Process Sheet

Customer	: CU-DAR001 Dart Helicopters Services	Drawing Name	: FLOAT SKIDTUBE ASSEMBLY
Job Number	: 31029		
Estimate Number	: 10309		
P.O. Number	:	Part Number	: D206642541
This Issue	: 3/7/2007 S.O. No. :	Drawing Number	: D3274 REV D
Prsht Rev.	: NC	Project Number	: N/A
First Issue	: 3/7/2007 Type : LANDING GEAR	Drawing Revision	: D
Previous Run	: 30969A	Material	:
Written By	:	Due Date	: 3/30/2007 Qty: 1 Um: Each
Checked & Approved By	: <u>07.03.07</u>		
Comment	: Est Rev:B 05-09-23 Revised per D206-642 Rev. J KJ/JLM Est Rev:C 07-02-23 Added SS Wearplates & Gaskets JLM

DESIGN CP	DRAWN BY PH	DART AEROSPACE USA, INC. PORT HADLOCK, WA	
CHECKED [Signature]	APPROVED [Signature]	DRAWING NO. D3274	REV. D SHEET 1 OF 4
DATE 06.12.19		TITLE SKIDTUBE ASSEMBLY	SCALE NTS
A	04.03.15	NEW ISSUE	
B	04.08.09	MOVE SADDLE HOLE: 42.14 WAS 42.76	
C	05.03.16	ADD -043; NEW INSERTS	
D	06.12.19	NEW INSERTS, SS WEARSHOE + GASKET

D3274-041 BEND/DRILLING DETAIL

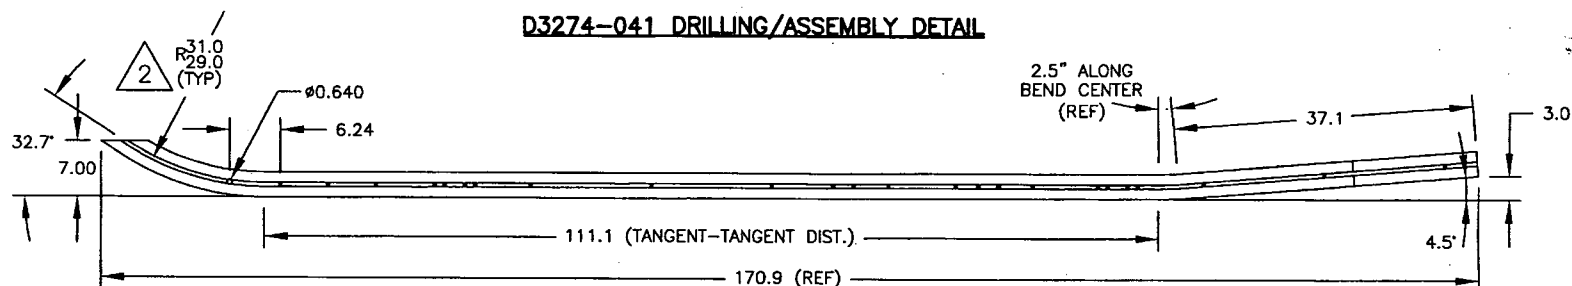
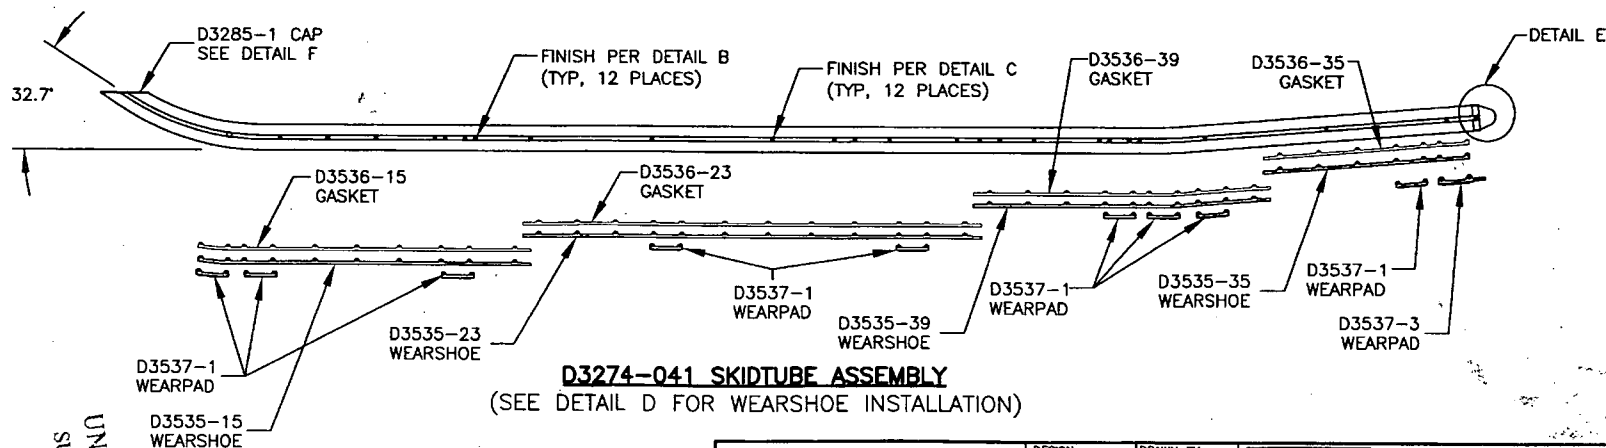
NCR:		WORK ORDER NON-CONFORMANCE (NCR)						
DATE	STEP	Description of NC Section A	Corrective Action Section B			Verification Section C	Approval Chief Eng	Approval QC Inspector
			Initial Chief Eng	Action Description Chief Eng	Sign & Date			
07-05-14	10.0	Tube was over bent in the aft section, up to 4.188" from 3.0". Same Programs, on 3 previous tubes, and all were good. R.C. Machine responded different to this tube.	07-05-14	Script as per e-mail. Over bent, will cause the center of gravity to move more forward on the A/C.	07-05-14	07-05-14	07-05-14	07-05-14

My apologies, the height is supposed to be 3.0" as per dwg D3274, pg2 of 4.

As I discussed earlier with Marc, the tube at 3.375" is acceptable and the tube at 3.60" is acceptable, but I think the tube at 4.188" should be scrapped.
